Docket Item # 7
BAR CASE #2009-0237

BAR Meeting
November 4, 2009

ISSUE: Additions and alterations

LOCATION: 5 Potomac Court

Figure 5. Existing and proposed site plan.

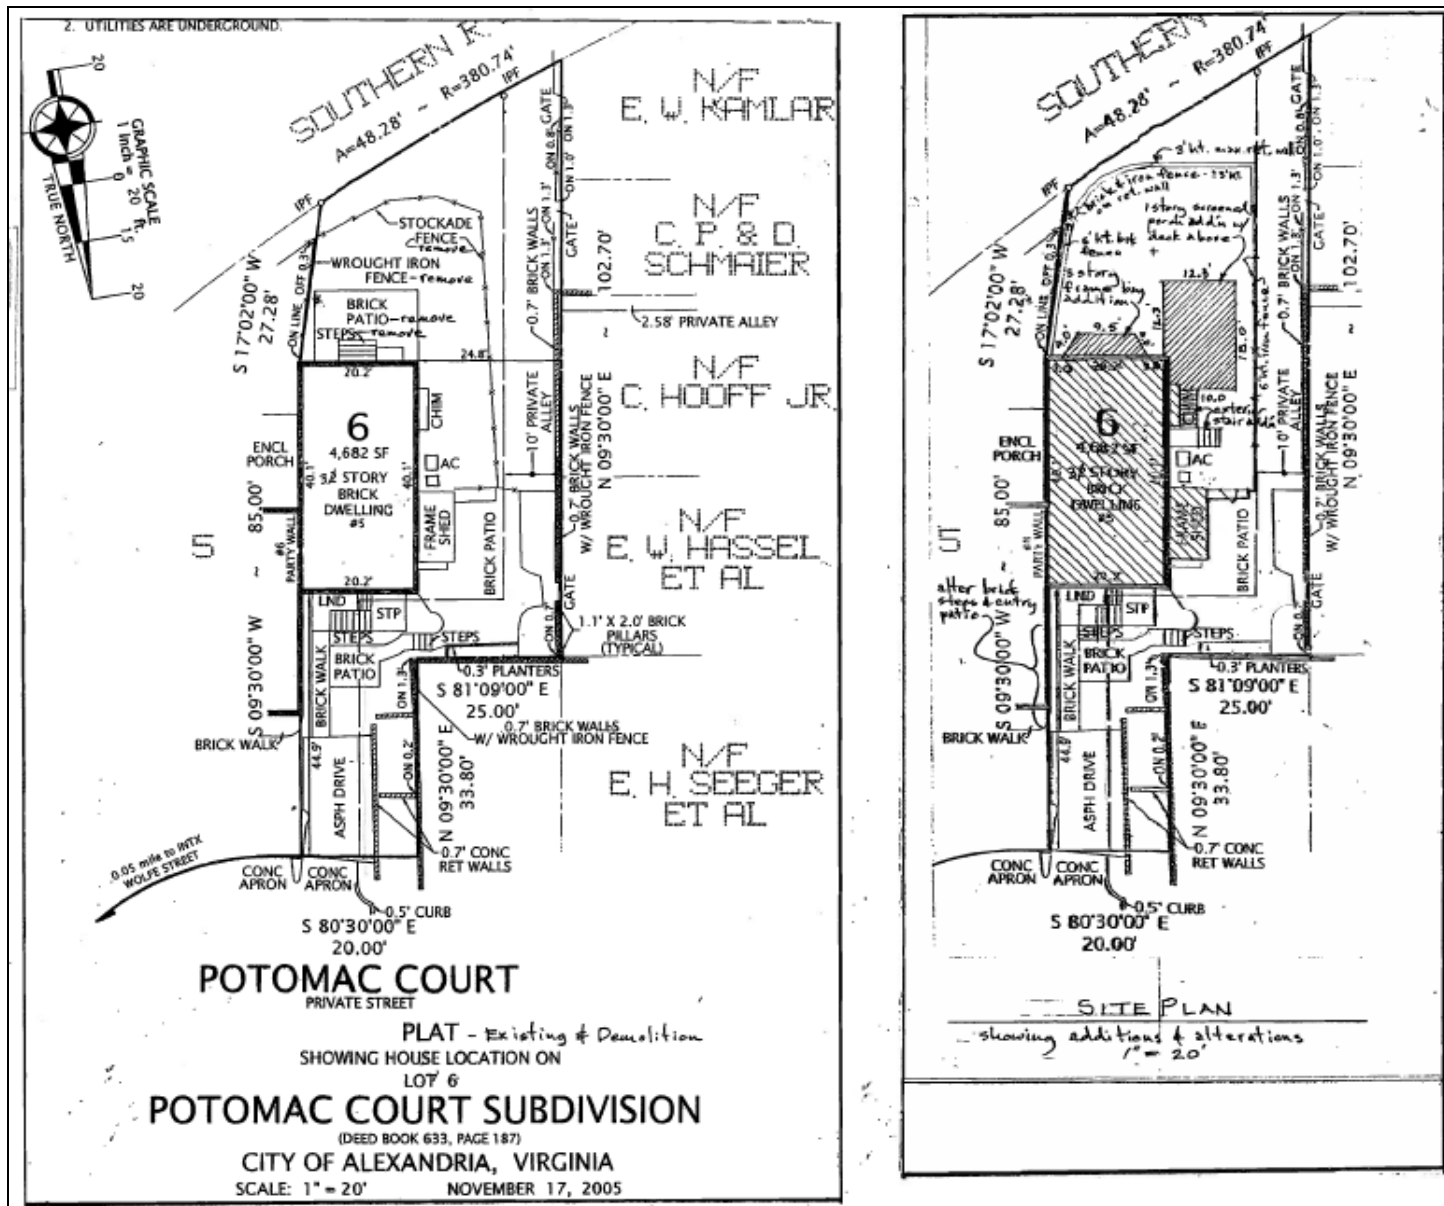
A combination of brick and iron fence, a brick wall, and an iron fence are proposed to replace an existing stockade fence on the east, west and south portions of the property. On the west property line the applicant is proposing a six foot iron fence. Along the southern area of the property is proposed a three foot retaining wall topped with an approximately three foot brick and iron fence.

The *Design Guidelines* note that “fences, garden walls and gates should be appropriate in materials, design and scale to the period and character of the structure they surround.” Furthermore, the *Guidelines* state that “masonry fences and walls of brick are generally appropriate throughout the historic districts.” Staff finds that the design of the proposed brick wall and iron fencing is compatible with the surrounding area.

1. The brick garden wall proposed to be installed near the property line adjacent to Windmill Hill Park is to be a maximum of six feet in height on the side facing Windmill Hill Park from the existing lowest topographic grade. The applicant shall also provide final design details and specifications for the brick wall and iron fencing to Staff for final approval prior to building permit submission.

Figure 6. Proposed north (front) elevation.

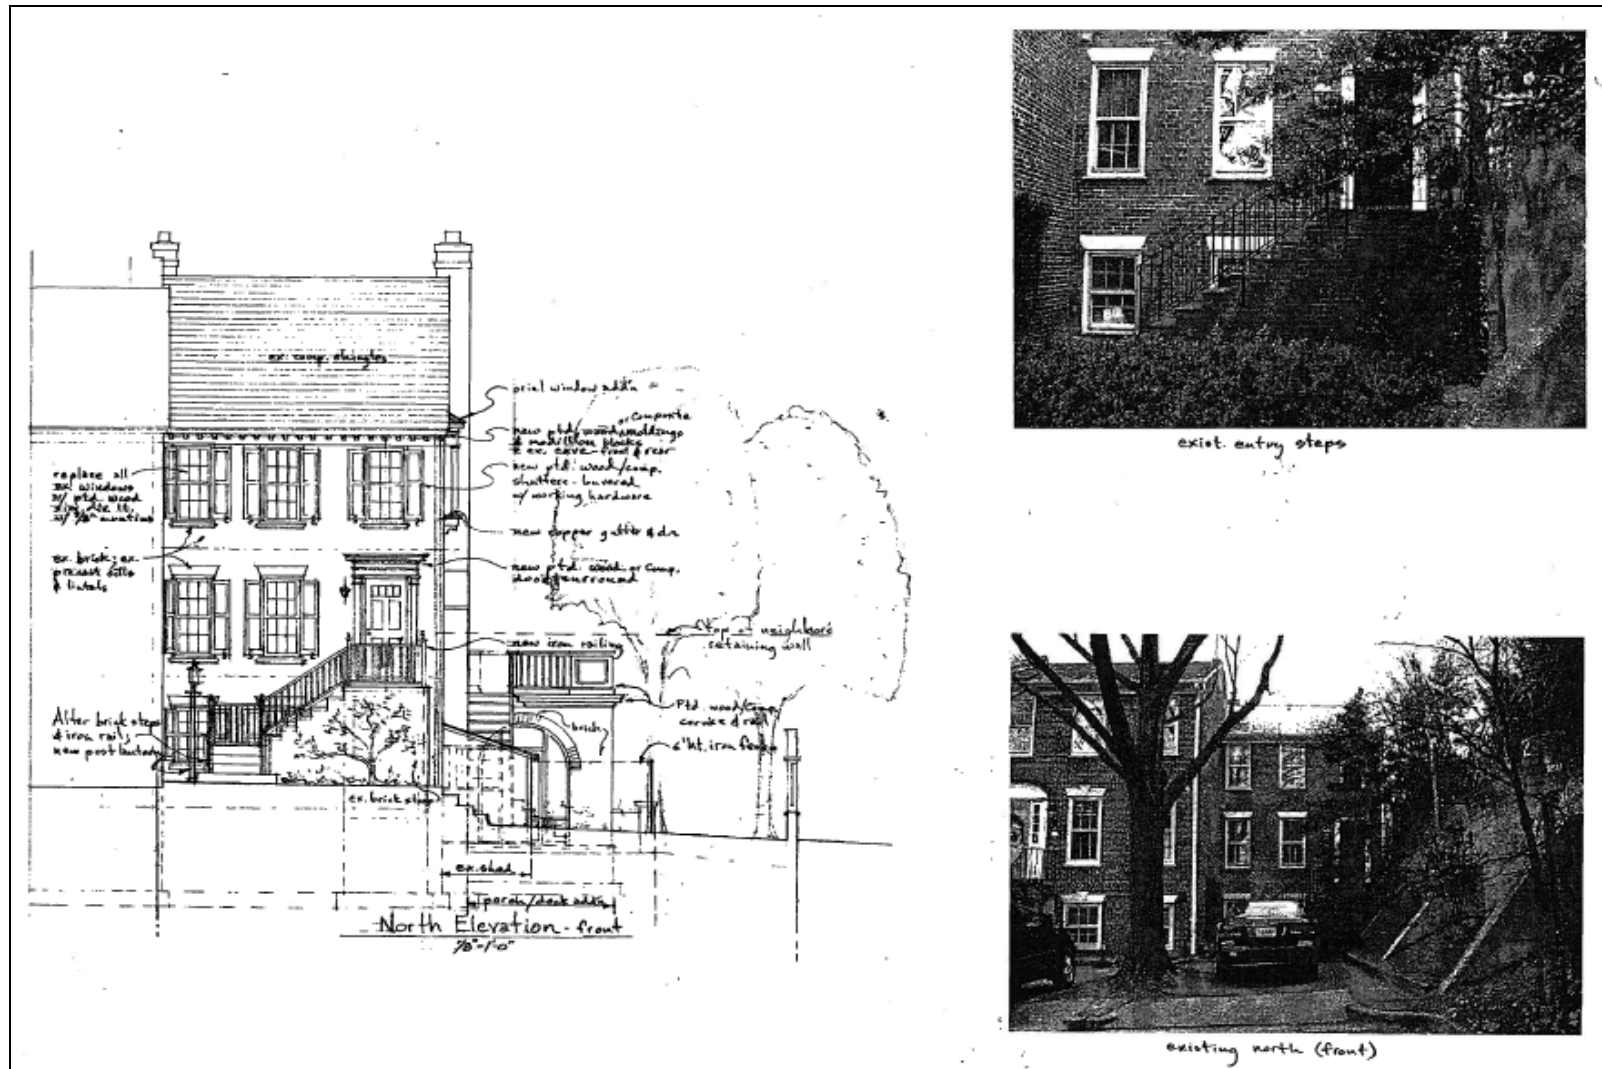
- All windows are proposed to be replaced with double-glazed, simulated divided light wood windows.
- All windows on the front elevation are proposed to have new wood louvered shutters. The shutters will be sized to fit the openings and will be operable. The easternmost shutters will not open fully due to the lack of space between 5 Potomac Court and its neighbor. These shutters will rest against the west wall of the adjacent house. The shutters are proposed to be a composite material.

- A new painted wood or composite material door surround and with a dentiled cornice is proposed. A new wood six panel door (with four lights) is proposed.

- A new painted wood or composite moldings and modillions at cornice is proposed.
- The existing straight-run stoop and iron railing is proposed to be realigned to incorporate a landing and 90 degree turn in the lower portion of the stoop.

- A new post and lantern is proposed at the base of the stoop.

2. That the front door be composed entirely wood and not be a synthetic or composite material, subject to final approval by Staff.
3. If the applicant chooses to use a composite material for trim, railings, and shutters, that the material be solid-through-the-core and paintable, with final approval made by Staff.

Figure 7. Proposed west (side) elevation.

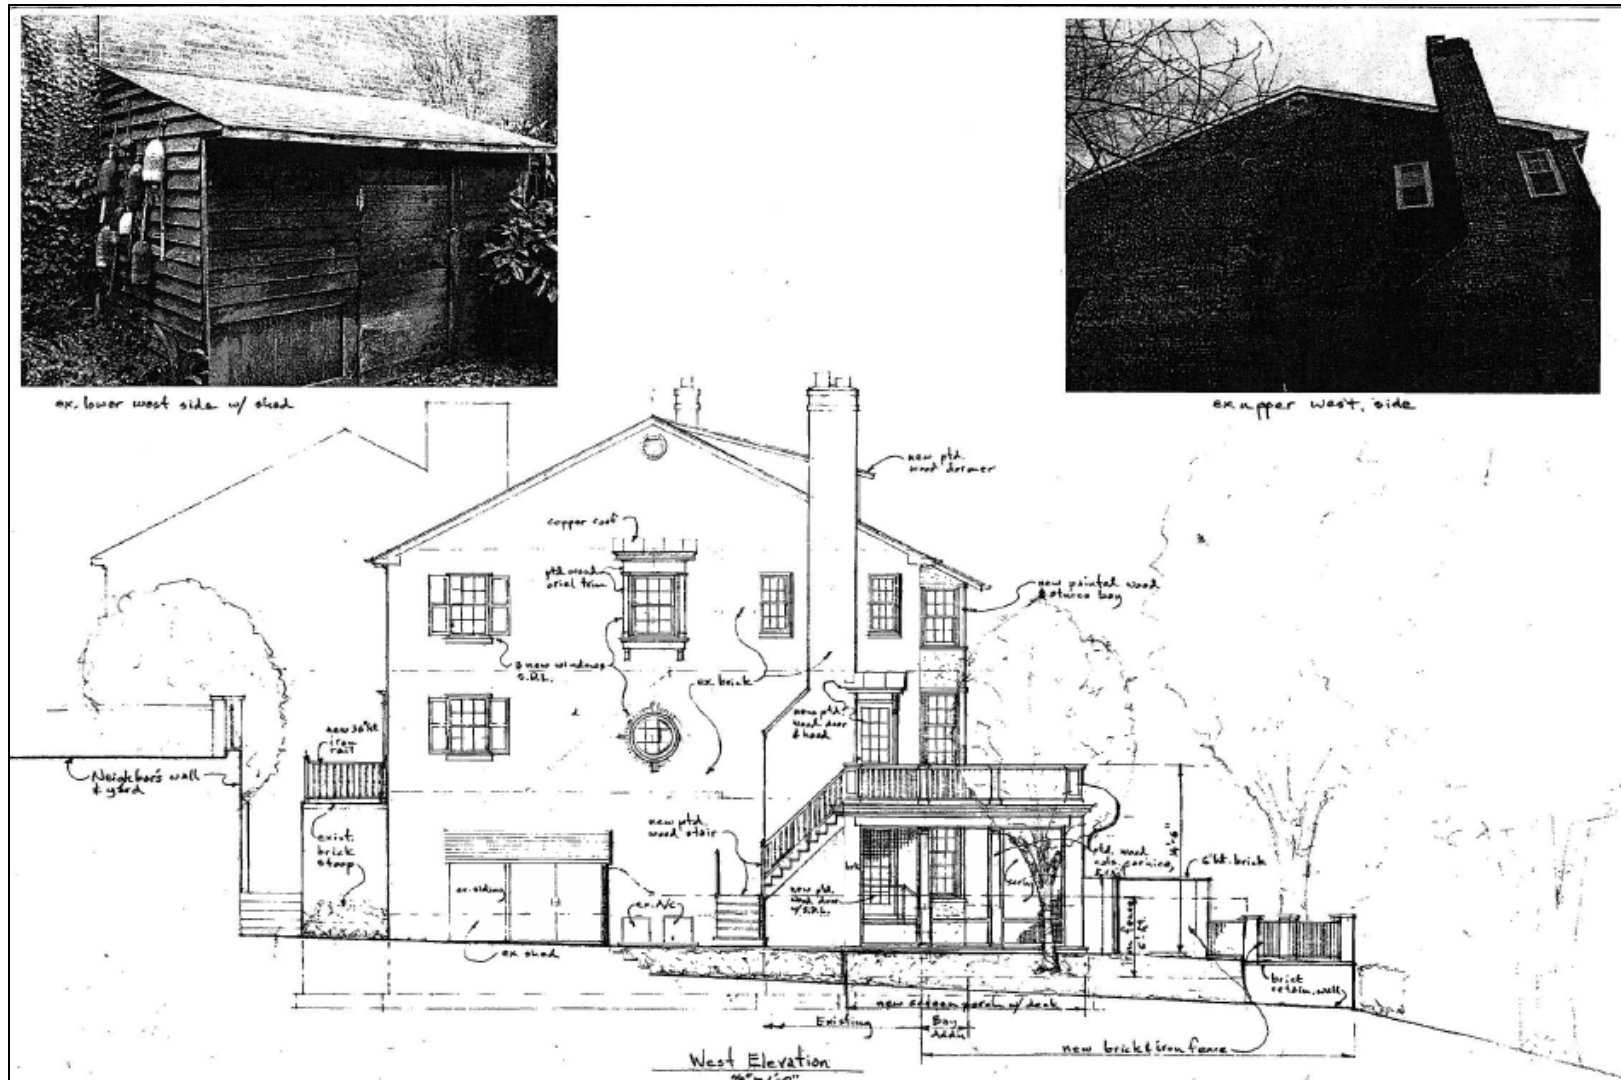
- A new ocular window is proposed for the first story. It will be a double-glazed, simulated divided light wood window with nine lights.
- Two new windows are proposed at the second story. The northernmost will be a six-over-six, double-hung simulated divided light wood window and will match the one

below at the first story. The second proposed window will be an oriel window at the center of this elevation directly above the proposed ocular window. This window will also have a six-over-six configuration and will have painted wood trim and a copper roof. The oriel window will project approximately one foot.

- Two doors are proposed to be added at the south end of the elevation on the first floor and ground floor levels. Both will be multi-light, simulated divided light wood doors. The upper door will lead to the deck and will have a copper clad hood. The lower door will lead to the screened porch.
- The proposed screened porch will be three bays on this elevation, extending approximately 23.5 feet. The corners will have brick piers and the interior columns and cornice will be painted wood.

Figure 8. Proposed south (rear) elevation.

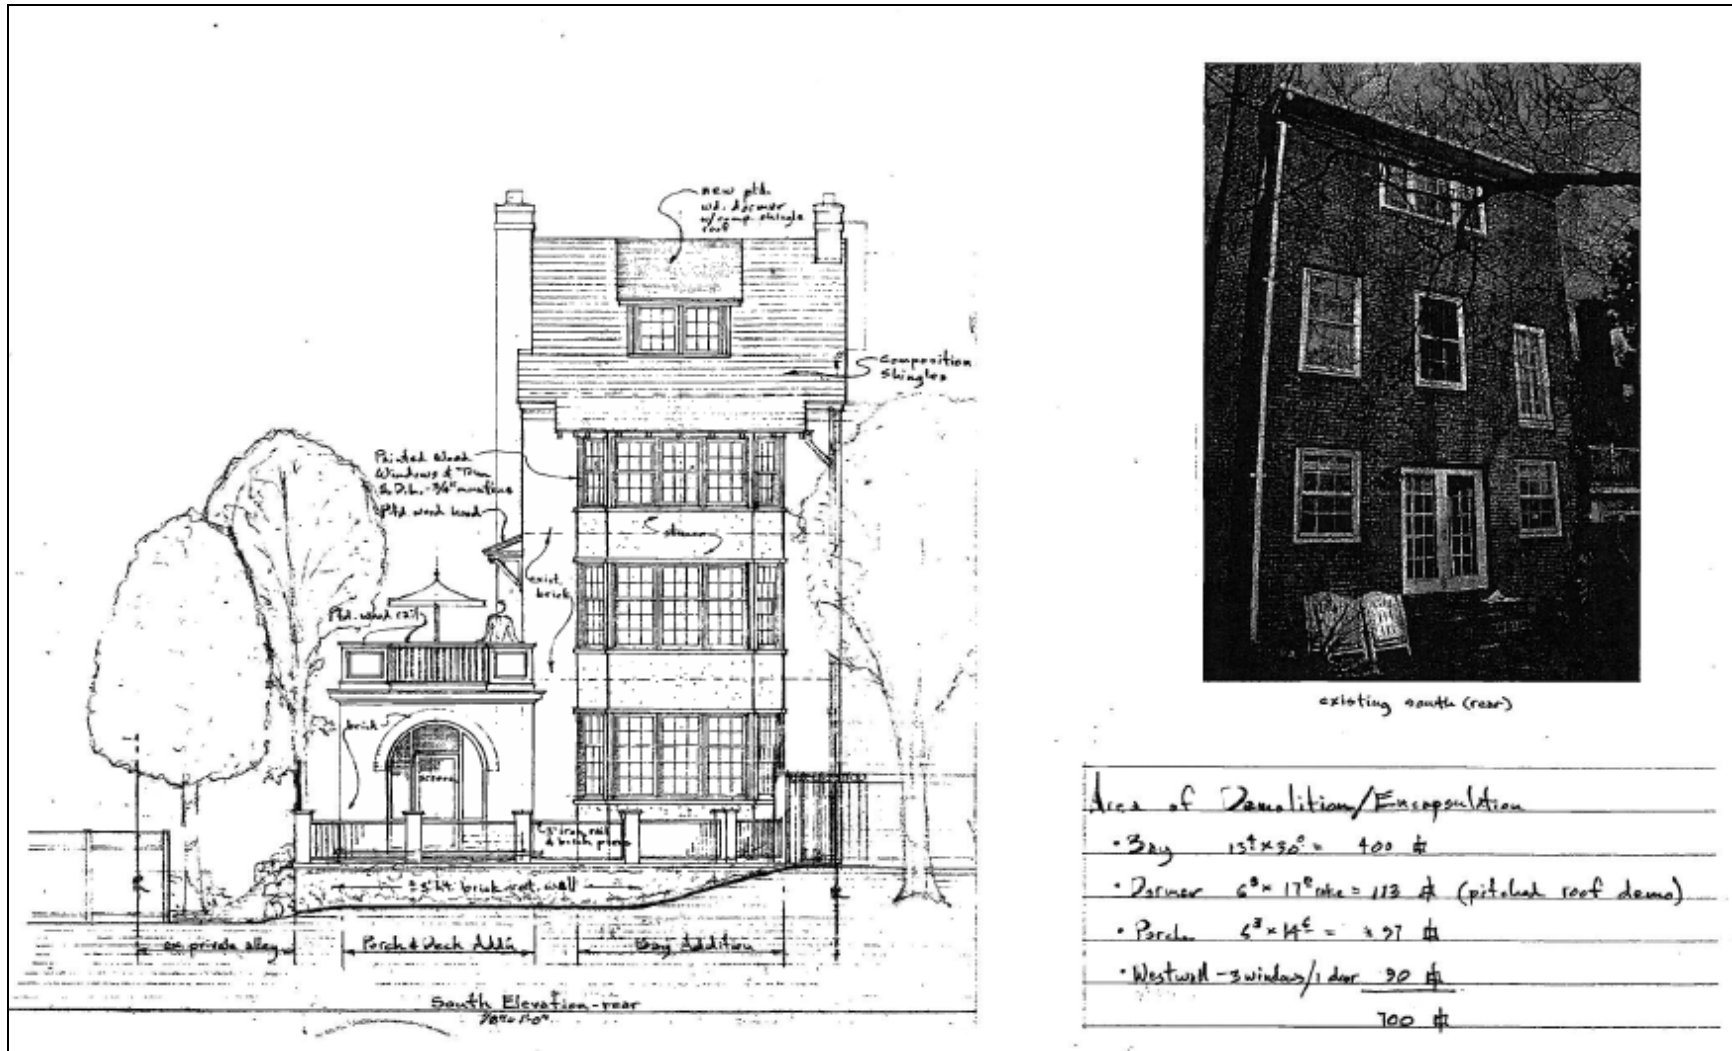
- The south elevation of the new porch and deck will match the north elevation. There will be a screened opening and door within a brick arch. The deck will have a painted wood railing between two wood paneled piers.

- A new three-story bay addition is proposed for this elevation. The projecting bay will measure approximately 13 feet four inches by thirty feet in height. Each story will have five six-over-nine, double-glazed, simulated divided light wood windows (three in the center portion with each side flanked by an angled one). The wall area between the floors will be clad in stucco. The shed roof of the bay will be an extension of the existing composition shingle.

- A shed roof dormer is proposed on this elevation. The dormer will have two multi-light windows. The trim will be painted wood to match the existing. The roof of the dormer will have composition shingle to match the existing. The width of the proposed dormer is six feet eight inches.

The most radical alterations will be at the rear of the building with the proposed new screened porch/deck and three-story projecting bay. Staff believes these additions, which are more elaborate in character and grand in scale than the original house, will be acceptable as they will not be readily visible with the more modest front of the house. In addition, the proposed screened porch and deck is a one-story element and will not be prominently visible. The projecting three-story bay element will be highly visible from Windmill Hill Park. However, any addition to the rear of this house would be highly visible from Windmill Hill Park. Staff previously recommended that the color of the stucco on the bay should be darker color close to the brick color to minimize its visibility and that the stucco color should be submitted to Staff for review and approval. The Board disagreed and found that not to be of concern.

Figure 9. Proposed east (side) elevation.

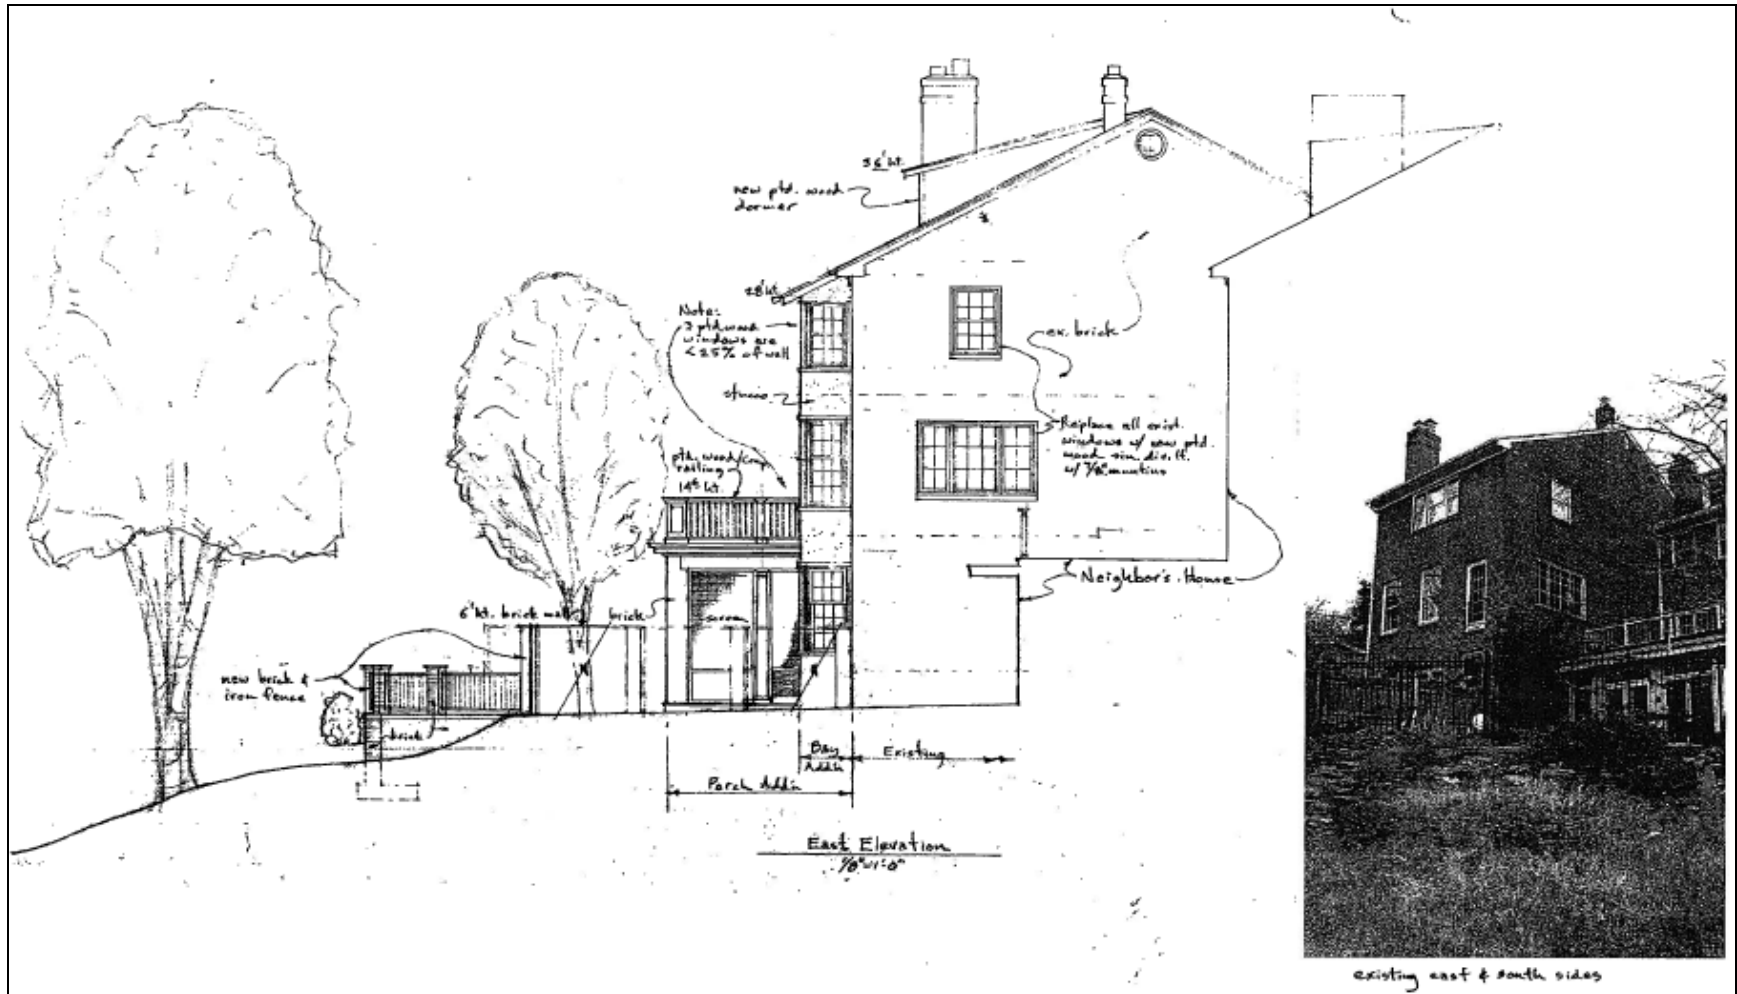
- The east side of the porch will have brick piers at the corners and a painted wood columns between the screens. As on the other elevations, the porch will have a painted wood cornice and the deck will have painted wood railing consisting of paneled piers and straight pickets.
- The existing windows on the east elevation will be replaced with double-glazed, simulated divided light wood windows with a 7/8 inch muntin to match the existing light configuration.
